Construction Division
Additions & Alteration Charges Approval Form

GULMOHAR RESIDENCY

Details of Additions & Alterations

Flat No	101	Block no.	'H'
Flat Area	1360 sft	Type A	Deluxe / Luxury
Buyer Name	Mr.		
Phone No.		Email

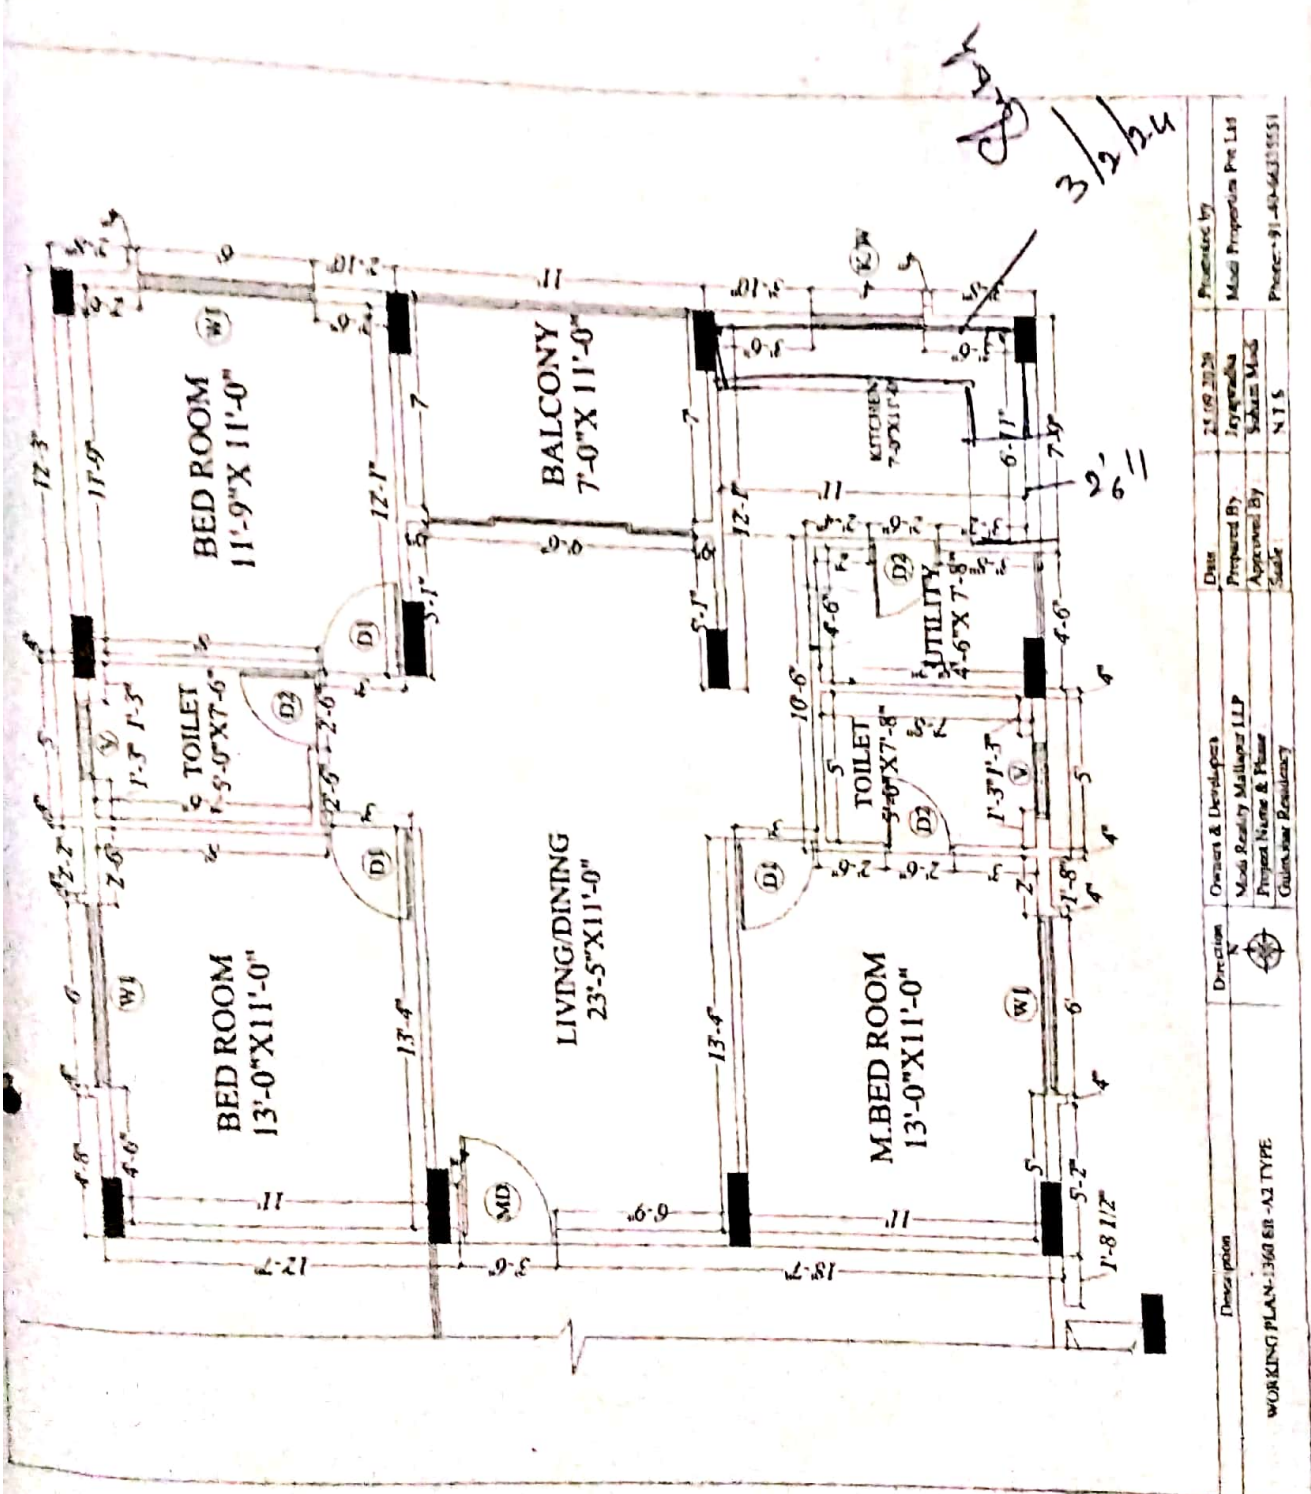
- ① 3 Bedrooms Automatic mowing - Kitchen floor
- ② Balcony - Oak and Dark (classy way)
- ③ Hall - Travertine marble
- ④ Utility - Black bay + slate white.

① Extra TV points @ Master & Guest Bedrooms.

- extra wash basin point

- ① kitchen platform granite will given by customer later.
- ② Edge tiles + ss sink given by customer. Not by company - 3/1/24
- ③ Sink by company - 3/1/24.

Description	Direction	Owners & Developers	Date	21.09.2020	Promoted by
ELECTRICAL PLAN - 360 sq ft FLATS-A2 TYPE		Modi Realty Mallapur LLP	Prepared By	Jayarambha	Modi Properties Pvt Ltd
		Project Name & Phase	Approved By	Soham Modi	Phone: +91-80-66335551
		Gulmohar Residency	Scale	NTS

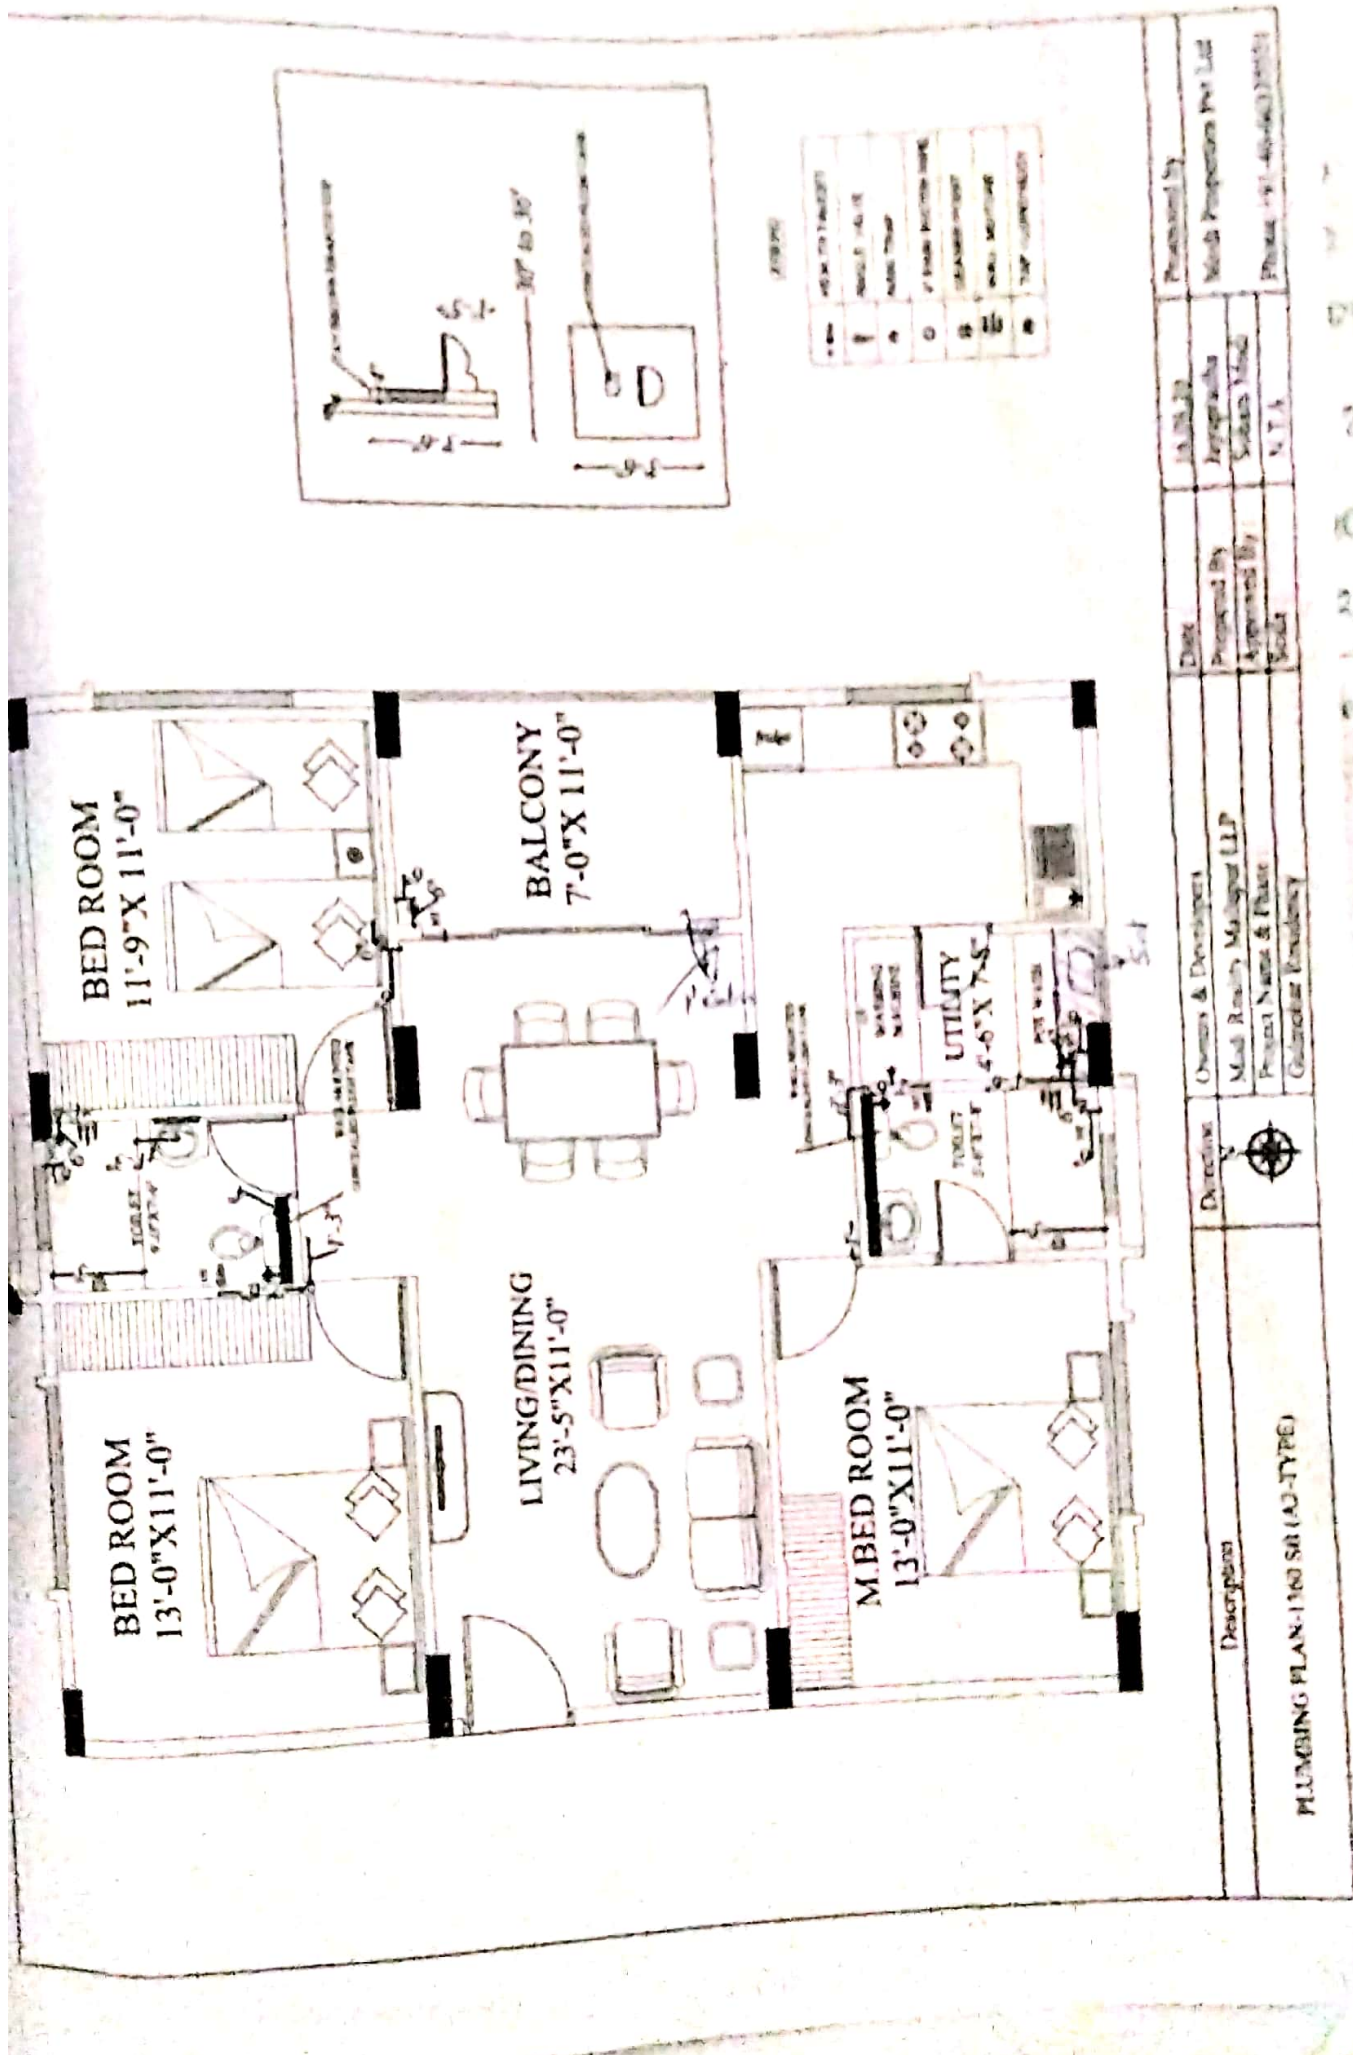
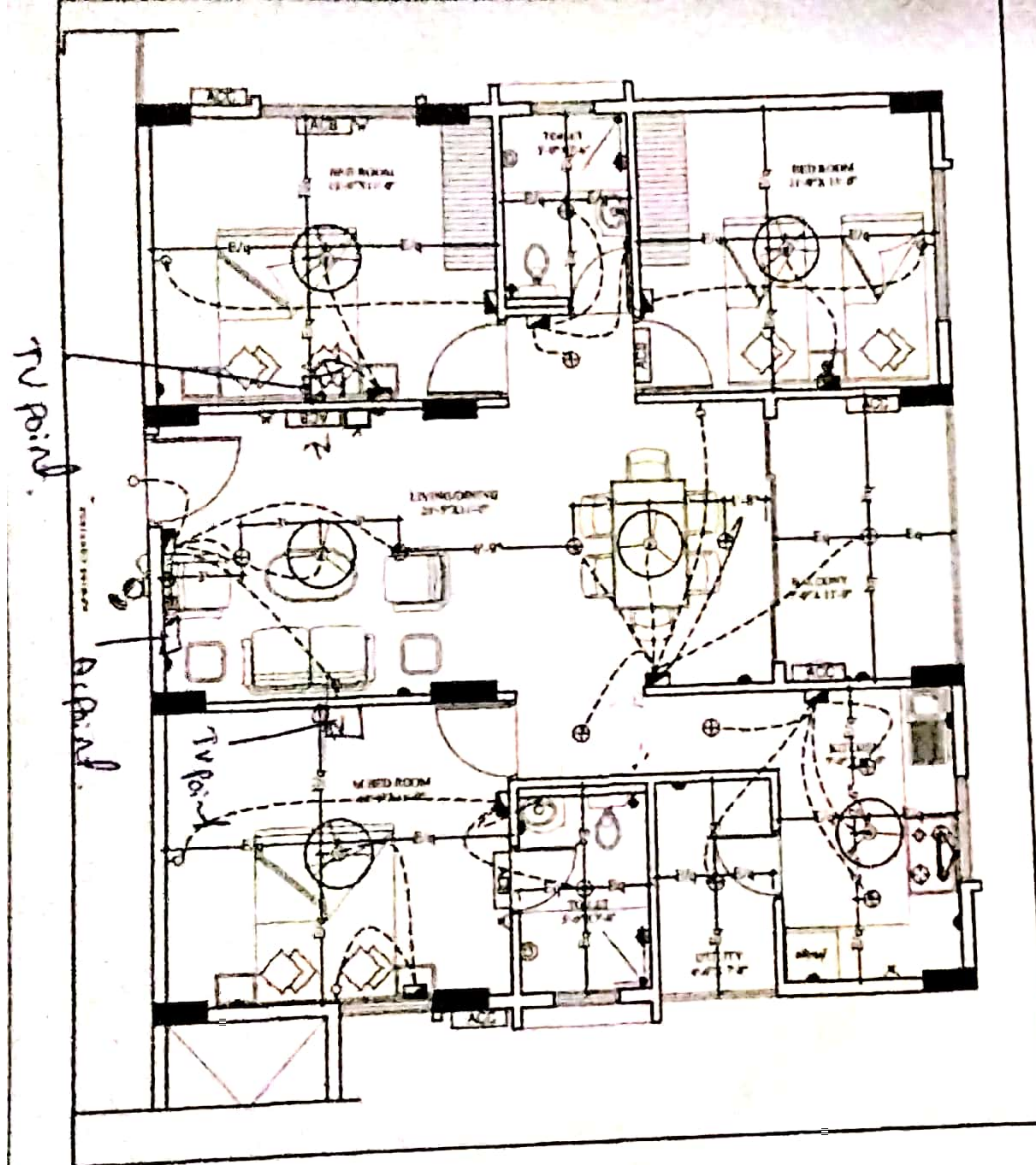
Changes in electrical points: (mark on plan)
